2 February 2026

OBJECTION to Application No. SSD-78996460
16-24 LORD STREET and 21-27 ROSEVILLE AVENUE, ROSEVILLE
Residential Development with In-fill affordable housing

Figure A: Excerpt of ADG Setback Requirements

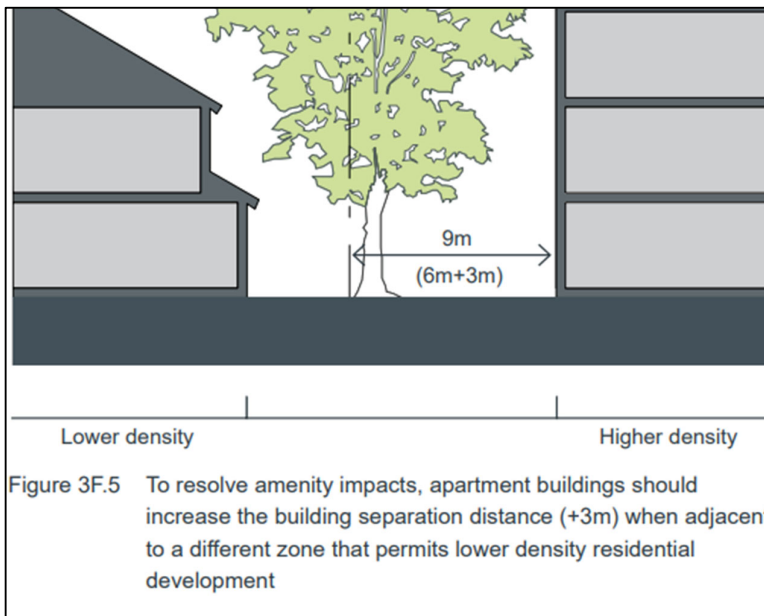
The second ground for my objection is that the proposed development is materially non-compliant with the ADG building separation controls. This would have huge deleterious impacts on the western neighbours at 19 Roseville Avenue and 14 Lord Street, both of which have been excluded from the TOD provisions and would therefore be a ‘lower density residential use’ when compared to the proposed development. Considering this, Figure 3F.5 of

the ADG applies and requires an additional setback of 3m (or more) to the western boundary (see **Figure A** below).

The proposed development does not comply with this requirement and does not offer any justification.

This non-compliance is contrary to Section 161 of the Housing SEPP. It also compounds the lack of a transition in scale between properties, increases bulk and scale relative to the neighbours and contributes to unreasonable shadowing and privacy impacts. Each of these matters are grounds for rejection of the Application.
